Models 707B, 708B, and all compatible cards

Version 1.03 Release

The 707B and 708B version 1.03 firmware is a problem fix release that also adds functionality. Some problem corrections may impact compatibility, please review the corrections prior to installation.

PR45831 **Models affected:**
707B

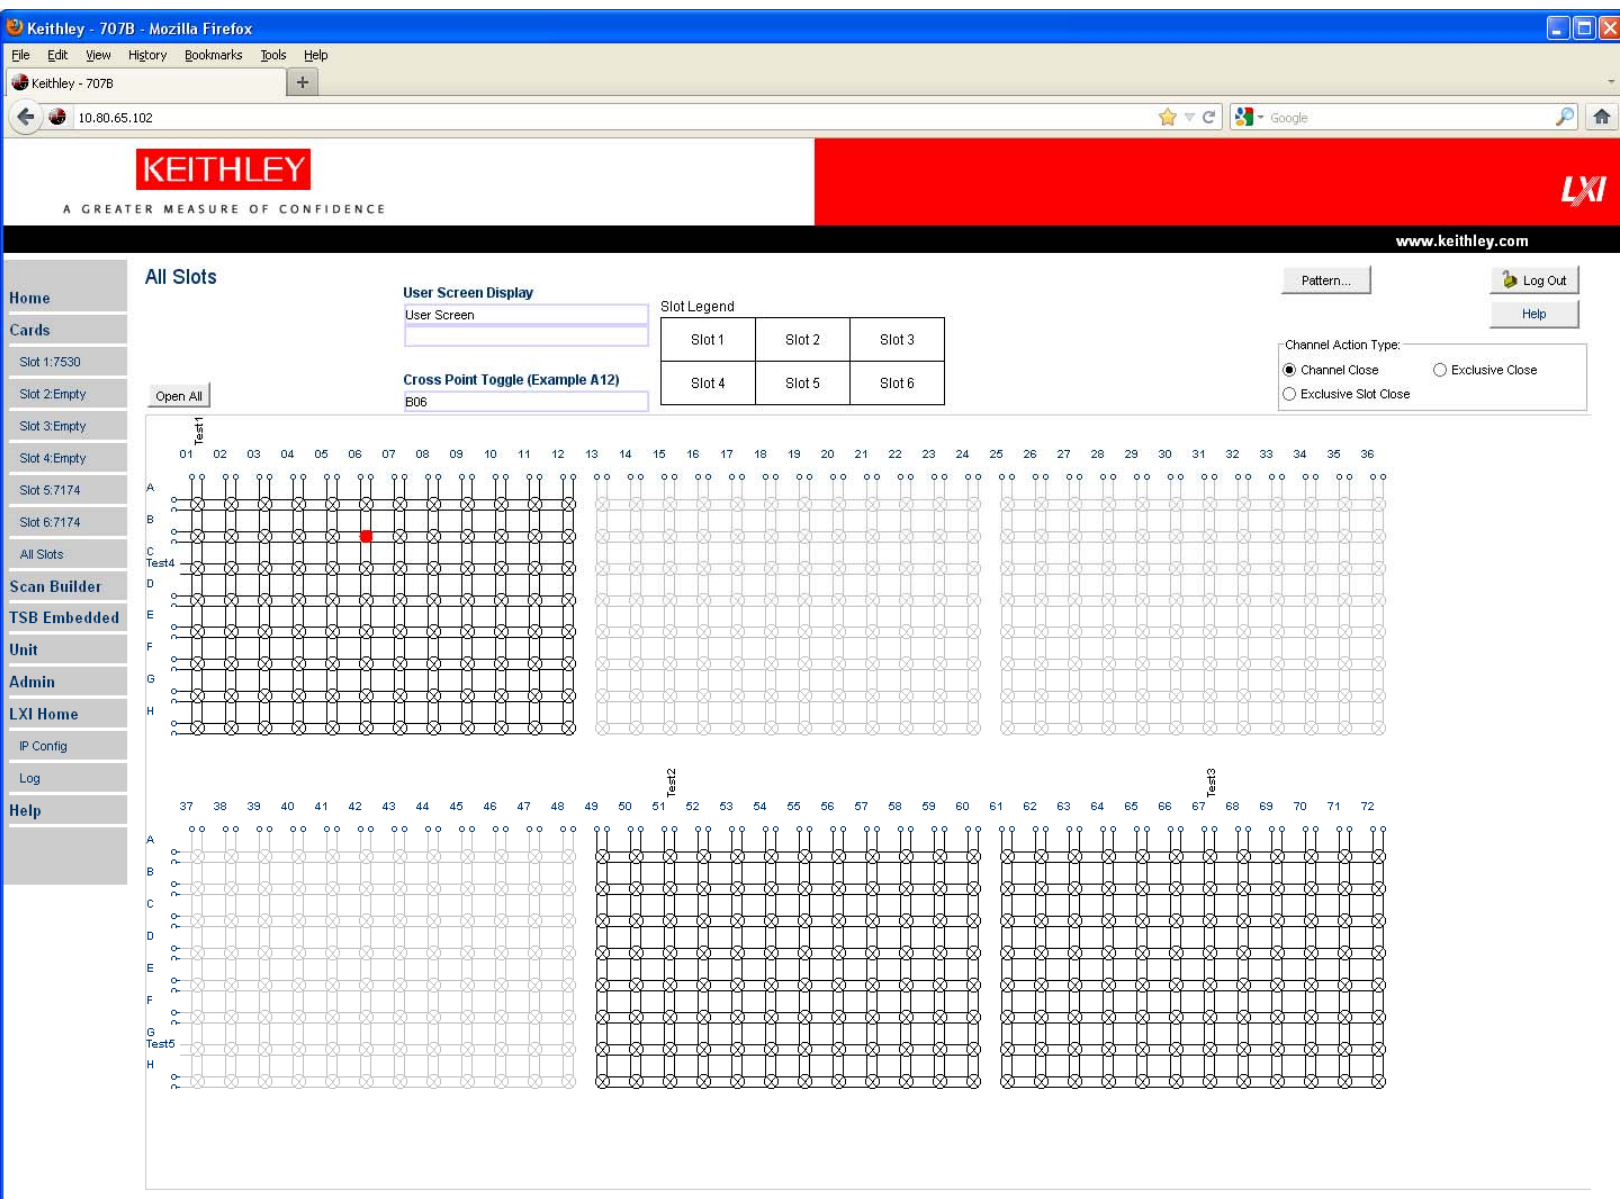
- Added All Slots view. (Shows all 6 slots)
- Added mirroring of both lines of the User Screen on the web applet. (Only in All Slots view)
- Added the Cross Point Toggle text box to allow toggling the state of a channel. (Only in All Slots view)
- Fixed login dialog window resolution issue.
- Fixed issue with card views that do not show properly at start of applet until window is resized.

- The All Slots view functions identically to the existing slots views with the following exceptions. The All Slots view shows all 6 slots in a single view. Each row and column has a static label and a user settable label. The user settable labels correspond to the labels that are displayed on the front panel and the other slot views in the applet. If the user settable labels have not been changed from their default values then they will not appear in the All Slots view. To change the user settable labels a TSB script can be run, a user settable label can be set in the single panel views of the applet or the user can right click on any of the static labels and modify the corresponding user settable label. The first set of user settable row labels are linked to the first card that is populated in slots 1, 2 or 3. The second set of user settable row labels are linked to the first card that is populated in slots 4, 5 or 6. A picture of the All Slots view is provided on the next page.

- The text boxes that display the User Screen will show both lines. They update automatically if the User Screen is updated and they do not require the user to login to the applet.

- The Cross Point Toggle text box accepts a channel address that is 1 character and 2 digits, the first is the letter corresponding to the row and the next 2 digits are the number of the column. Example: A12. The address is not case sensitive. After entering an address pressing the Enter key will cause the corresponding channel to toggle states. Continuing to press the Enter key will cause the channel to continue toggling states. This text box requires the user to login to the applet.
